January 13, 2026 Planning Board Meeting

Application filed by Matthew Hall, 76 Brook Trail Road Concord, MA 01742. The subject property, 151 Main Street, Maynard, MA 01754, is in the Business zoning district (B), within the Downtown Overlay District (DOD). Per Section 10.5.1.2 & Section 10.5.1.4 of the Town Zoning By-laws (ZBL) the applicant is requesting Site Plan approval for construction of a mixed-use project at 151 Main Street consisting of 2,705 square feet of retail and office space on the first floor, and three (3) apartment units on the 2nd and 3rd stories above. The project is subject to Section 10.6 of the ZBL (Design Review) and the Design Review standards of the Planning Board's Rules and Regulations. Per Section 9.4.8.3 of the ZBL, the applicant is also requesting a Special Permit to reduce minimum parking requirements for the project.

PROJECT NAME 151 Main Street

Peer Review Comment Form

SITE DEVELOPMENT PLAN
 FOR: **MATTHEW HALL**
 SCALE: 1"=20' **OCTOBER 9, 2025**
 REVISED: DEC 4, 2025

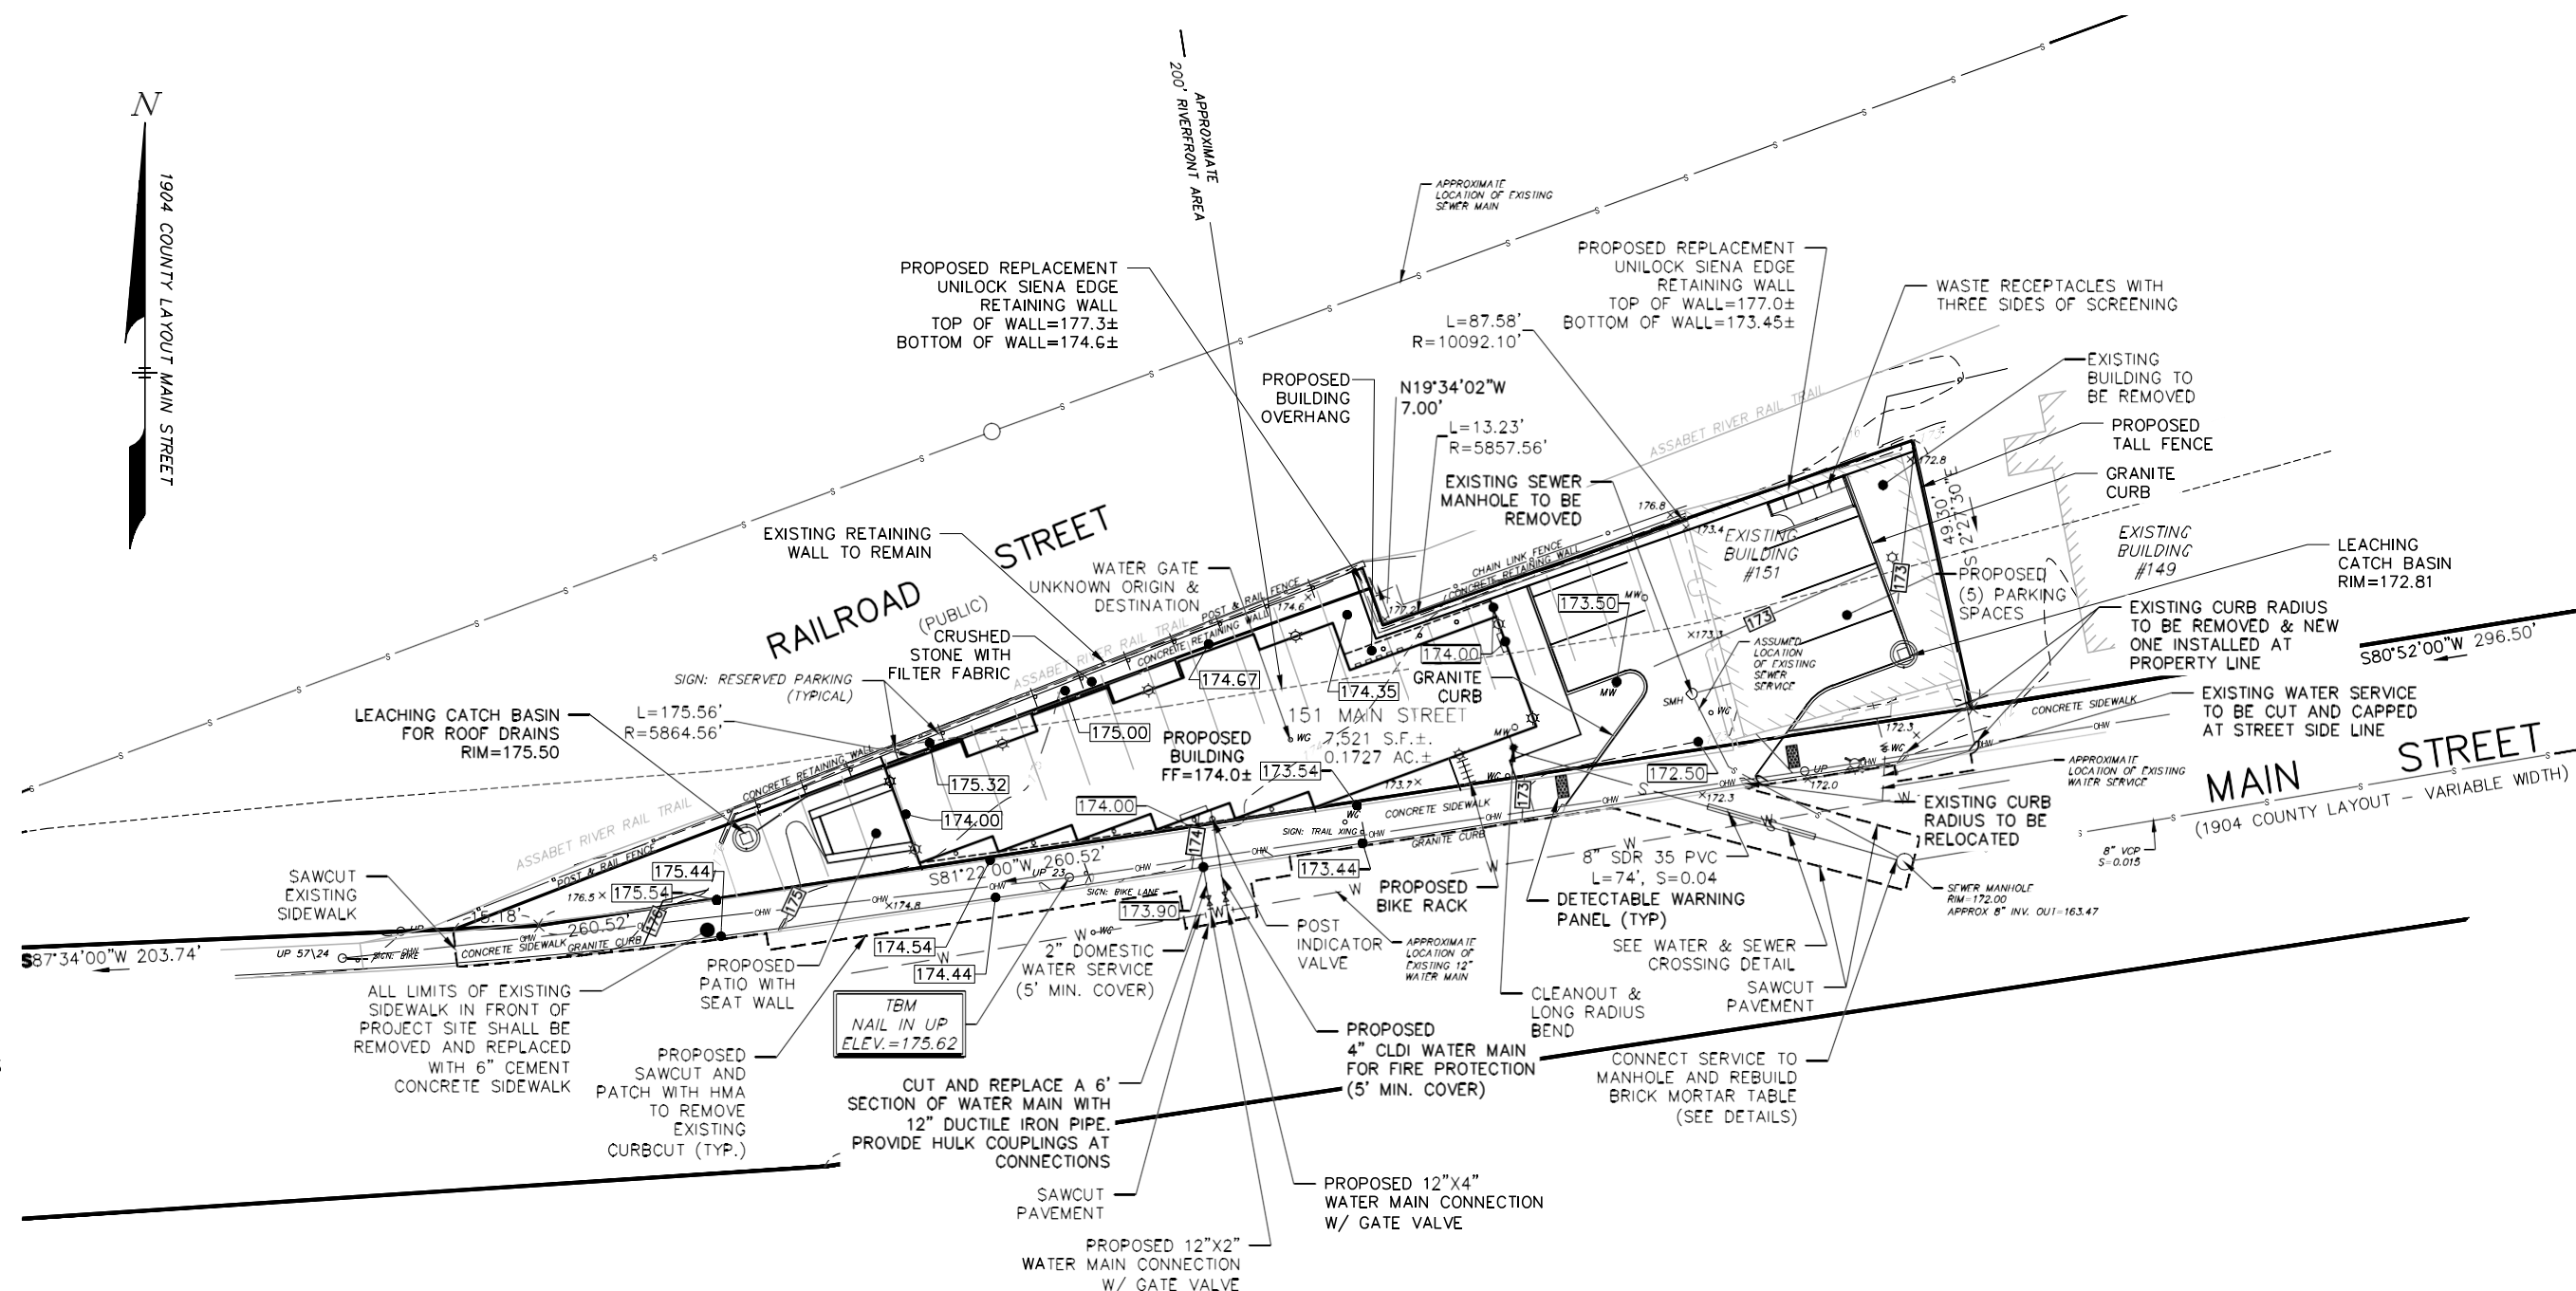
5	Site Development Plan		A cape cod berm and granite curb is proposed in the parking lot. A granite curb is recommended to hold up better against snow plows. Please consider revising.	All curbing is now proposed as granite.	VR	12/9/2025
6	Site Development Plan		It is recommended that the curb line on the eastern portion of the site moves the curb cut to the property line since the old curb cut for the garage door is no longer needed. Please consider revising.	The existing curb cut on the eastern portion of the site is now proposed to be moved to match the eastern edge of the frontage since there will be no garage there after this project is completed.	VR	12/9/2025
7	Site Development Plan		Is the existing wall being removed and replaced with a new wall or are the walls going to be next to each other? Any items to be removed should be called out on the plans. Proposed walls should be detailed on the plans with the existing walls if they are to remain. Please revise.	The rail trail retaining wall is to remain as is, and the other wall replaced with a unlock retaining wall. The labels for the walls have been updated.	JT	12/23/2025

SITE PLAN
151 MAIN STREET
IN
MAYNARD, MASSACHUSETTS
(MIDDLESEX COUNTY)
UTILITY PLAN

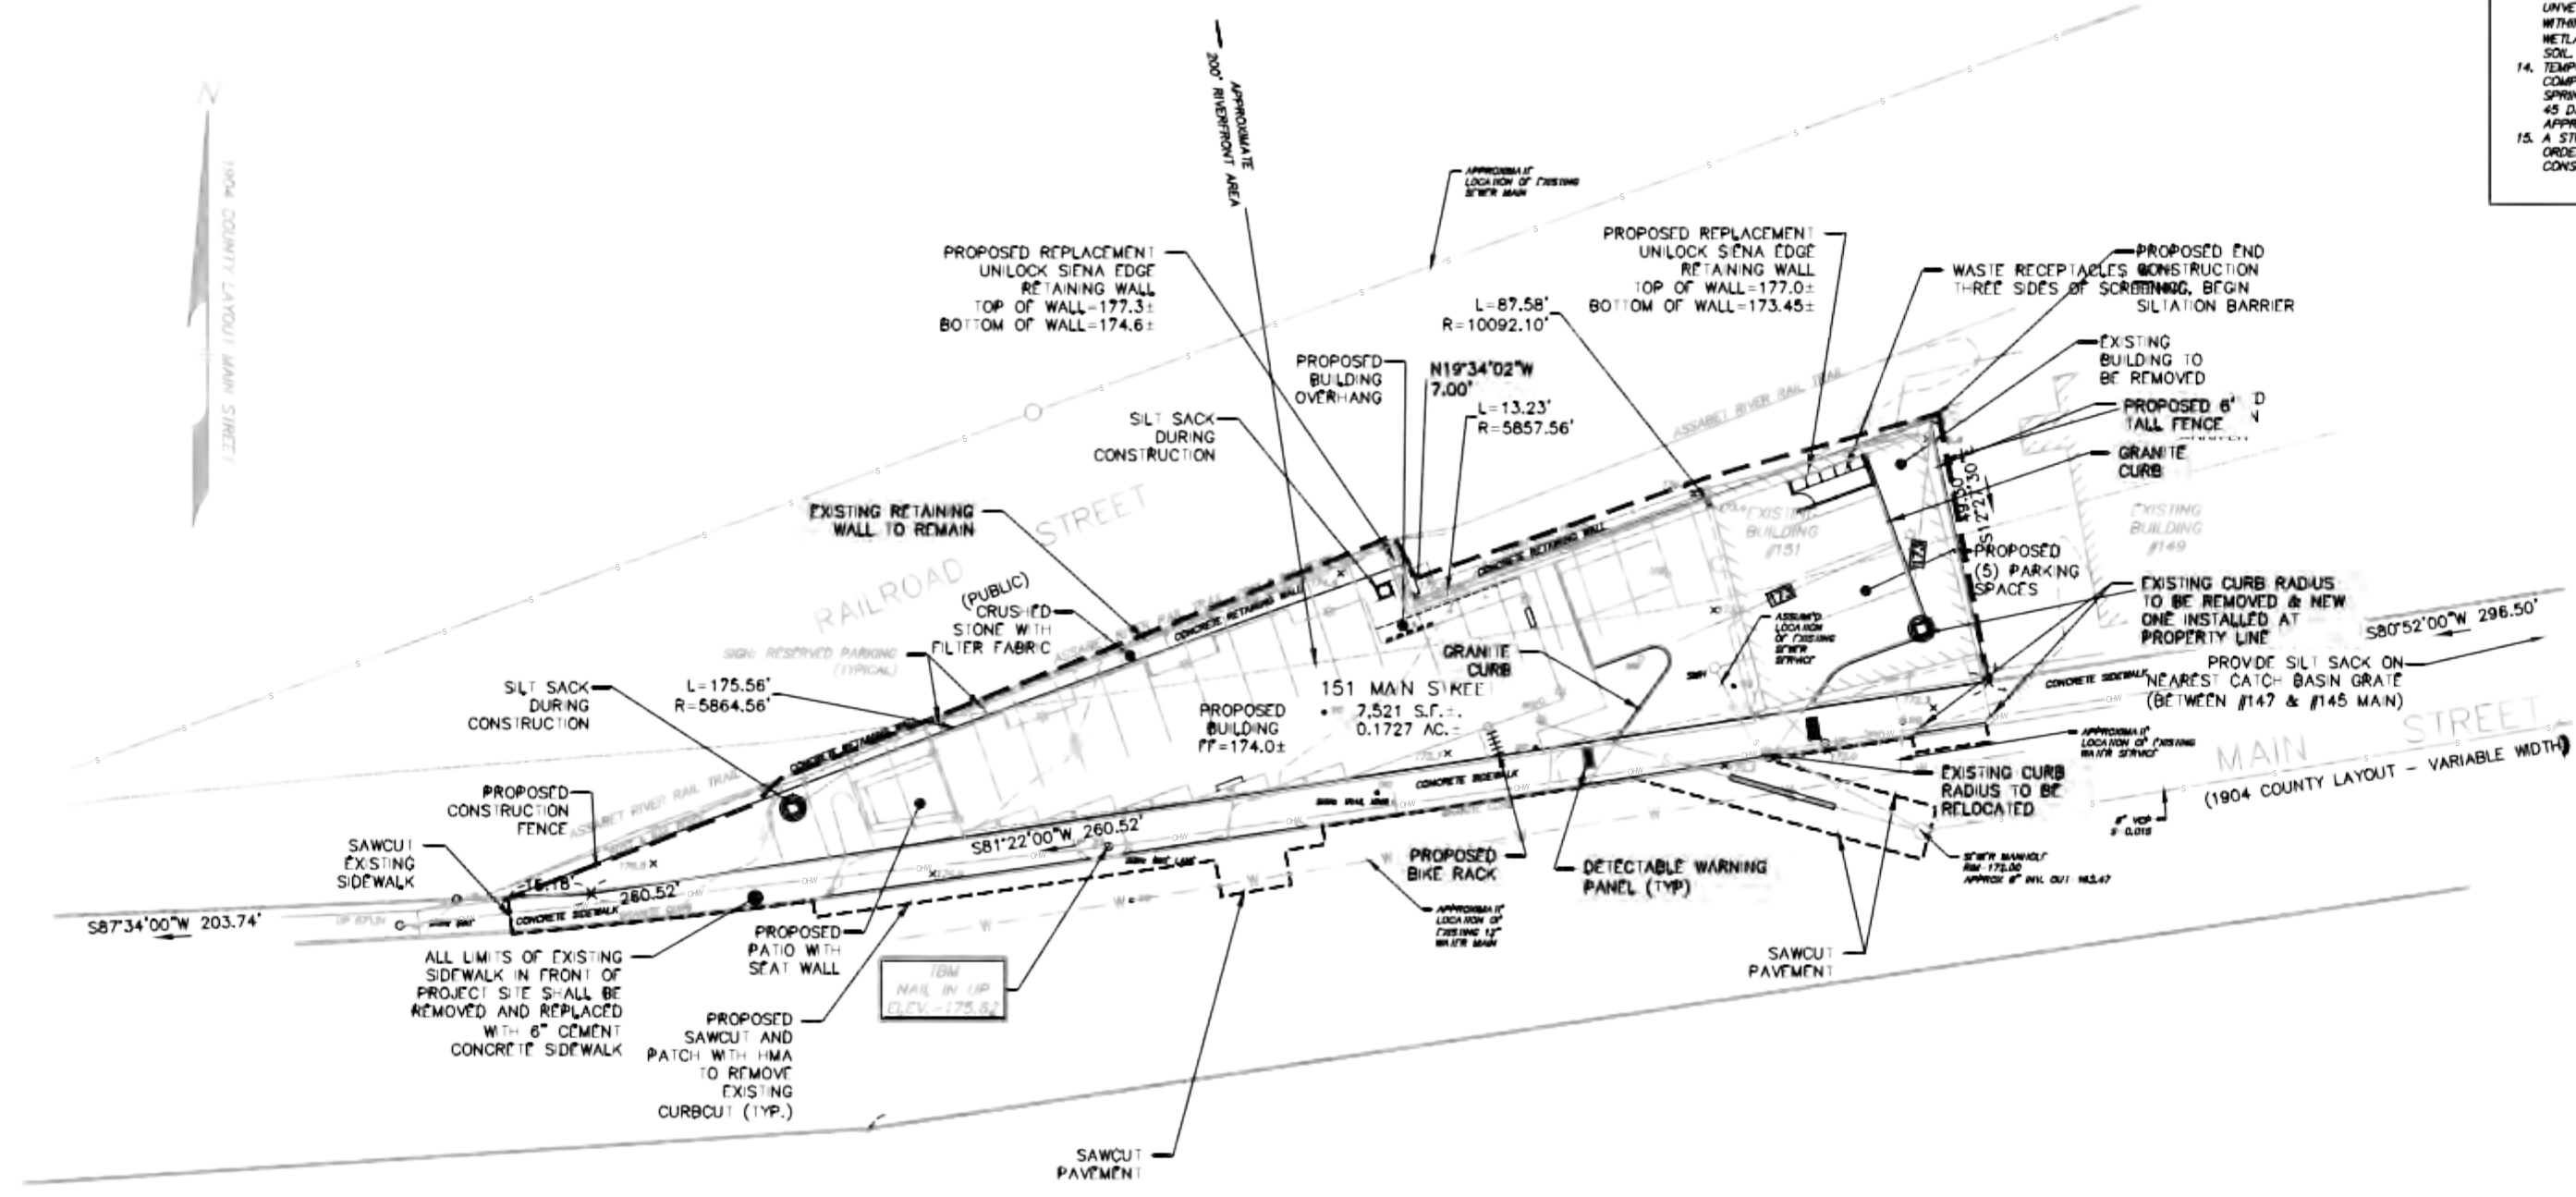
14	Utility Plan	PB Rules & Regs C.9	Has a system capacity analysis been performed and submitted to the DPW?	The DPW has confirmed adequate capacity for this project in terms of water demand.		
14A	Utility Plan	PB Rules & Regs C.9	We defer to the DPW for approval.			
15	Utility Plan	PB Rules & Regs H.3	Has the project been reviewed by the Fire Department to confirm how fire alarm and terminal boxes shall be installed and for fire access to the site?	The fire alarm and terminal box layout has not yet been finalized but will be coordinated with the Maynard Fire Department.

NO.	SHEET NO.	SECTION	GREEN'S COMMENT	Applicant's RESPONSE	CONFIRMED BY	DATE
15A	Utility Plan	PB Rules & Regs H.3	We recommend this be made a condition of approval.			
16	Utility Plan		The WATER MAIN CONNECTION DETAIL shows both an 8" and a 12" existing water main, please clarify. This also only seems to be a detail for the fire protection line, please revise or provide additional detail to also show the 2" domestic service. Also, the plan indicates a cut in tee but the detail indicates a tapping sleeve and valve. Please confirm with the DPW on the preferred connection.	The detail has been corrected to note the water main as 12". The detail has also been added to say "or 2" domestic".		
16A	Utility Plan		We defer to the DPW for approval.			
17	Utility Plan		Have test pits been performed to confirm soils are suitable for infiltration and the seasonal high groundwater is at least 2' below the bottom of the leaching basin? The soil onsite is potentially contaminated. Have soil sampling been performed to confirm the contamination of the soil is ok for infiltration BMPs? This should be sampled and confirmed by an Licensed Site Professional (LSP).	No, site is covered by Building and paving. Construction of the rail trail at the west corner did not encounter contaminants.	JT	12/23/2025

17A	Utility Plan		Based on the Planning Board Hearing, the Engineer is responsible for confirming the leaching basin has adequate separation to groundwater so, the BMP will function properly.		JT	12/23/2025
18	Utility Plan		WATER & SEWER CROSSING DETAIL the detail does not match what is shown in the plan. In the detail, the water main has the sleeve, but in the plans the sewer has a sleeve. Typically the sewer is encased at the crossings. Please clarify.	The detail has been corrected with the water and sewer pipe labels swapped to accurately reflect how the sewer line is proposed to be encased at the water crossing.	VR	12/9/2025
19	Utility Plan		How will the sewer manhole and pipe be abandoned? Will it filled and plugged at the active manhole?	The DPW has requested that the sewer manhole be removed. The pipe can be abandoned in place or removed from site if encountered during construction.	JT	12/23/2025

20	Utility Plan		It is not recommended to have an infiltration BMP such as the leaching basin within 10 feet of a building even if it is on a slab foundation. Please consider revising.	The leaching catch basin behind the proposed building has been removed.	VR	12/9/2025
21	Utility Plan		A detail for the crushed stone in the rear of the building should be provided. It is unclear from the grading, is this area able to drain out to the east behind the building?	Added a dispersion trench detail for the rear of building, surface flow graded to drain out	VR	12/10/2025
22	Stormwater Pollution Prevention Plan		Please indicate on the plans where each erosion control measure is being proposed.	Sheet 6 of the plan set shows a construction fence around the whole area of work, except for where a siltation barrier is proposed along the eastern edge of the project. Most of the site is downgradient of the neighboring areas except for this eastern portion. Additionally, silt sacks are proposed within the on-site proposed catch basins as well as in the existing catch basin between #145 and #147 Main Street (label with arrow on plan).	JT	12/23/2025

Detail: Photometric Calculation

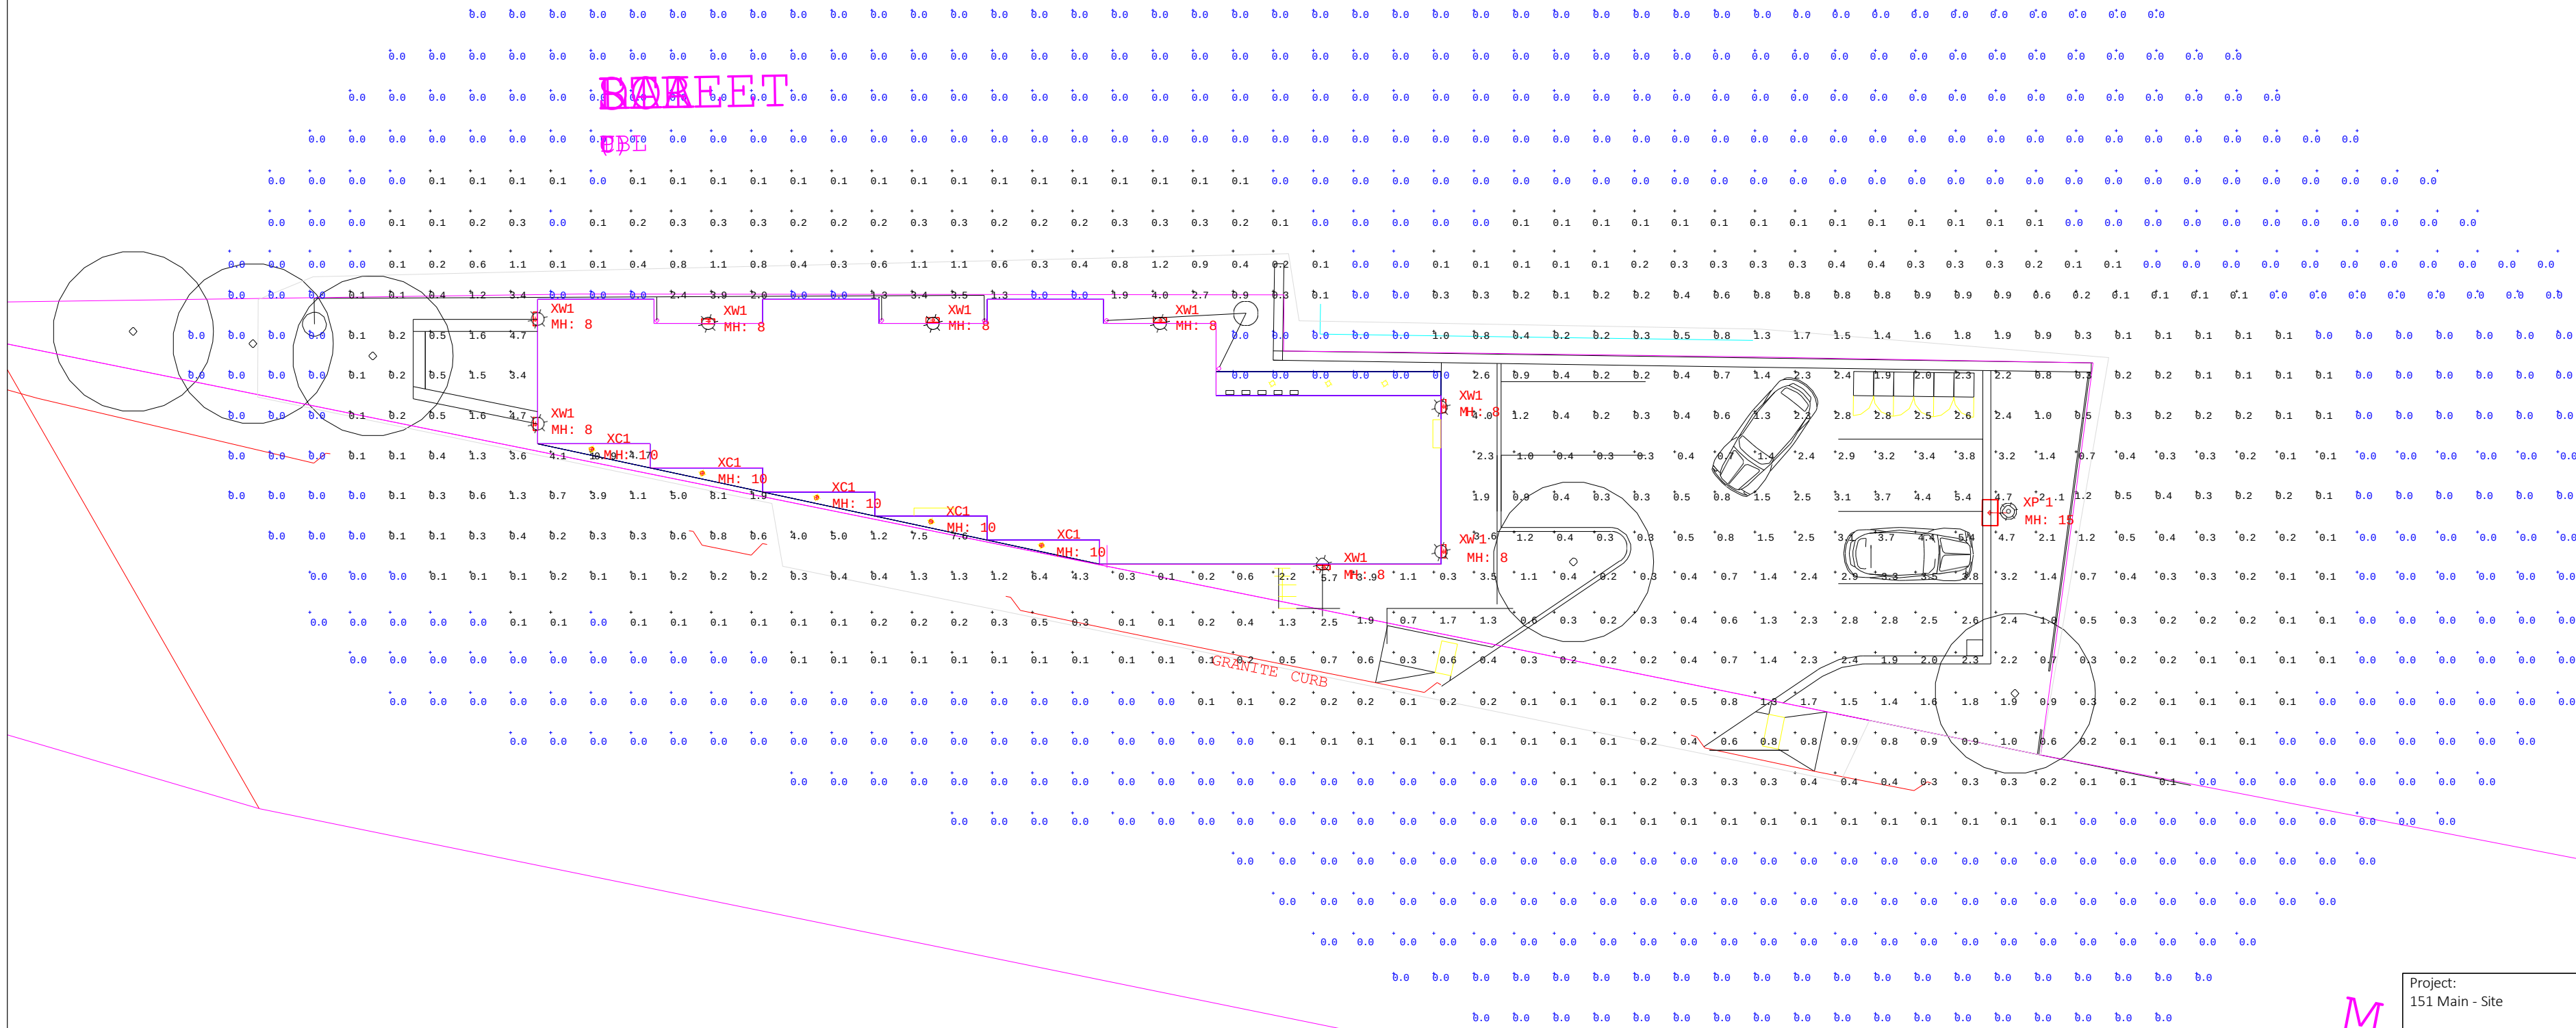
NO.	SHEET NO.	SECTION	GREEN'S COMMENT	Applicant's RESPONSE	CONFIRMED BY	DATE
30	Photometric Plan	PB Landscape Regs 5.9.2	Please confirm the shut off controls such as sensors, timers, and motion detectors to turn off lights when not needed.	Exterior lighting will be on timers located in mechanical area on the ground floor	JT	12/23/2025
31	Photometric Plan	PB Landscape Regs 5.9.2	Light spill across the property lines should not exceed 0.1 foot candles adjacent to business properties. The current light spill on the adjacent property to the east exceeds 0.1 foot candles. Please revise.	Please see PB comments regarding light levels at entries and north side.		
31A	Photometric Plan	PB Landscape Regs 5.9.2	We defer to the Board for approval.			
32	Photometric Plan	PB Landscape Regs 5.9.2	It is recommended that at building entrances and sidewalks foot candles do not exceed 5 fc. Please revise.	Please see PB comments regarding light levels at entries and north side.

32A	Photometric Plan	PB Landscape Regs 5.9.2	We defer to the Board for approval.			
33		Stormwater Management Regulations 7.A	The required stormwater treatment volume was not provided. Therefore, it is assumed that the project disturbs less than 10,000 sf. Please confirm the square feet of disturbed area is less than 10,000 sf or provide the required and provided stormwater treatment.	The project disturbs less than 10,000 square feet (the entire lot is only 7,521 square feet).	VR	12/10/2025
